Commission Agenda Report

Planning Commission Meeting
03-16-26
Item 5.B.

Subject: Coastal Development Permit No. 23-073, Variance No. 25-019, Site Plan Review No. 23-035, and Minor Modification No. 24-005 – An application for the construction of a single-family residence and associated development

Location: 32832 Pacific Coast Highway, within the appealable coastal zone
APN: 4473-017-023
Owner: Sun is Shining, LLC

PLATE 1	**GOLD COAST GEOSERVICES, INC.**			
	OWTS PLOT PLAN			
	32832 PACIFIC COAST HIGHWAY, MALIBU			
DATE: 06-01-2023	SIZE: C	CLIENT: SUN IS SHINING, LLC		REV: 02-2024
FILE NO: GC22-083354	SCALE: 1" = 30'	DRAWN BY: GH	APPROVED BY: SJH

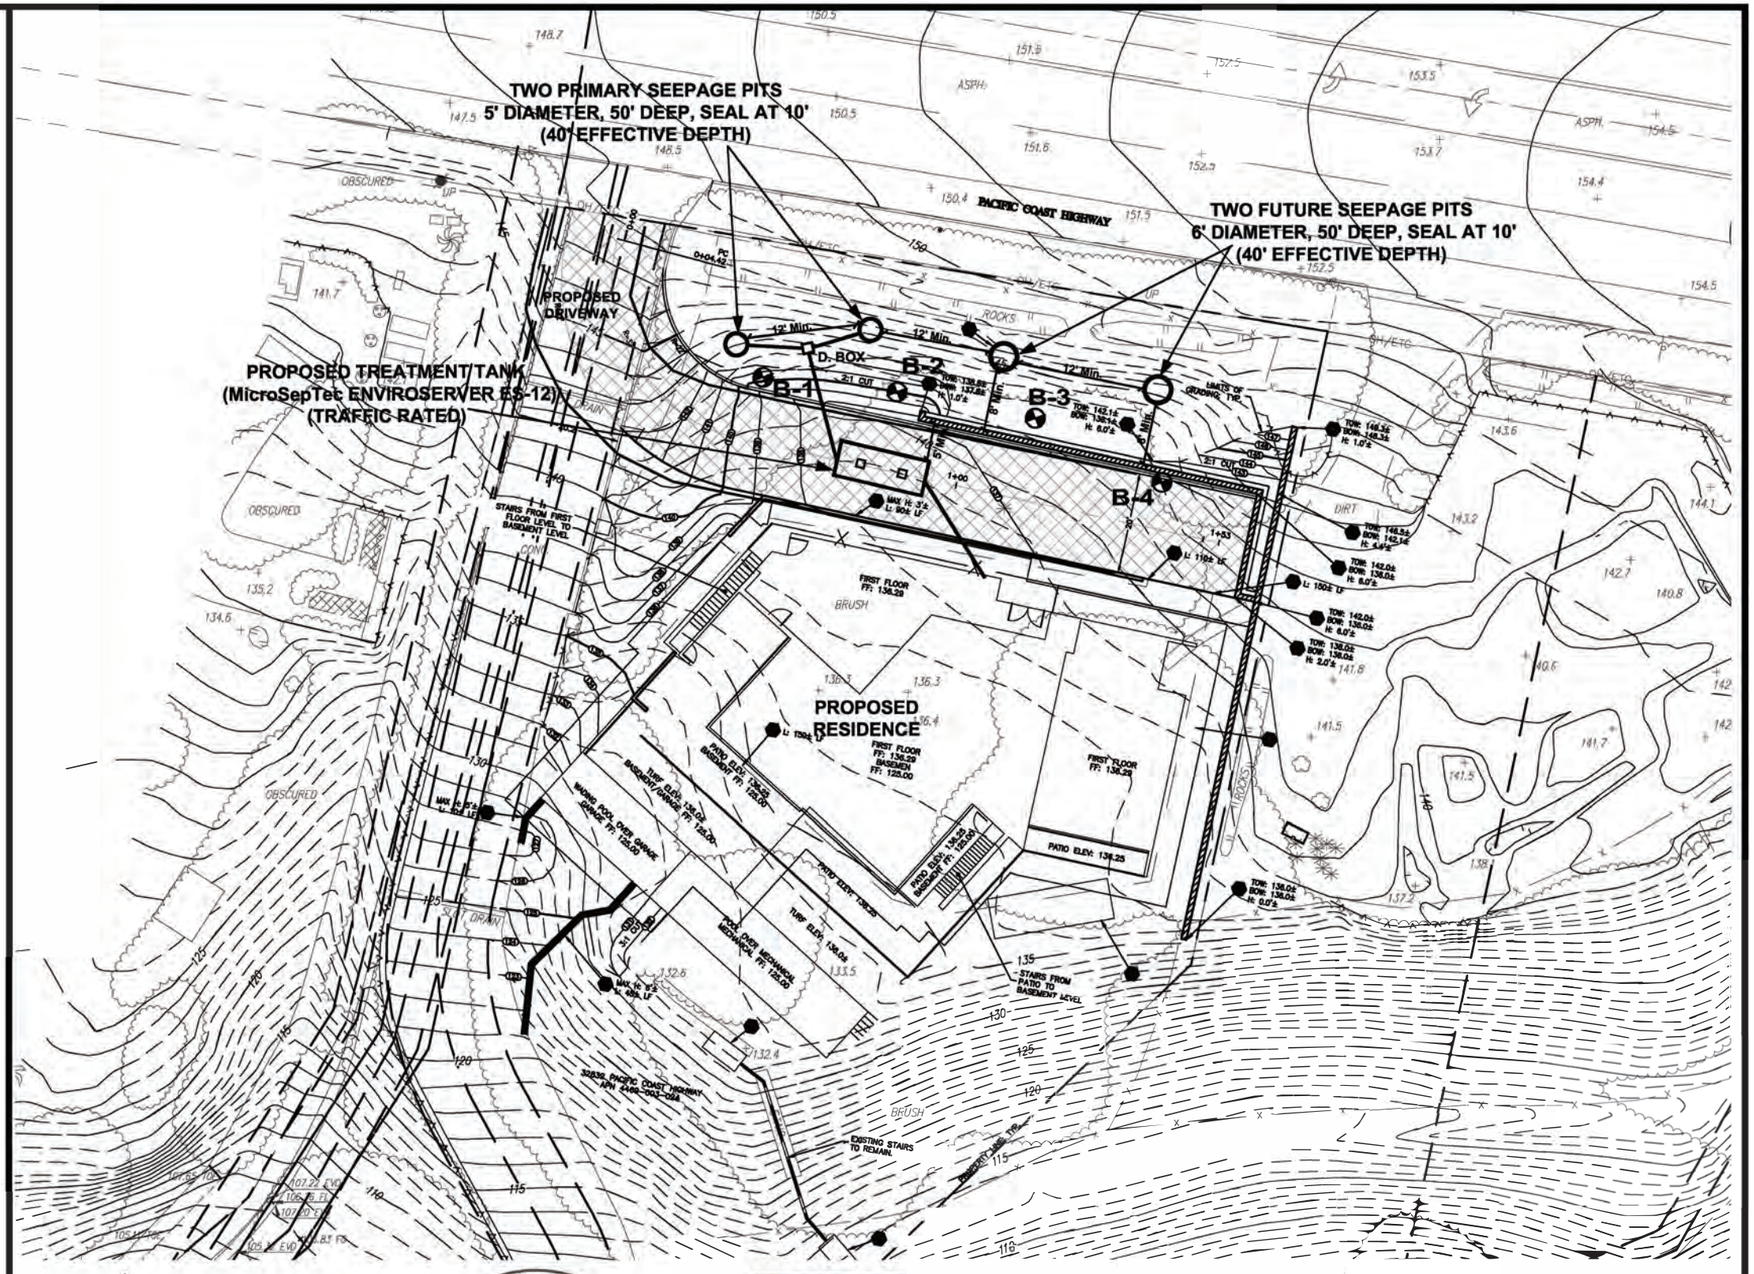
- Sheet A1.01 of the architectural plans depicts an outdoor sink. Per the 2016 California Plumbing Code, stormwater shall not be drained into sewers intended for sanitary drainage (1101.3). All outdoor fixtures must be covered by a permanent cover to decrease uncontrolled flow into the OWTS. Revise the plans, accordingly, and submit for review.
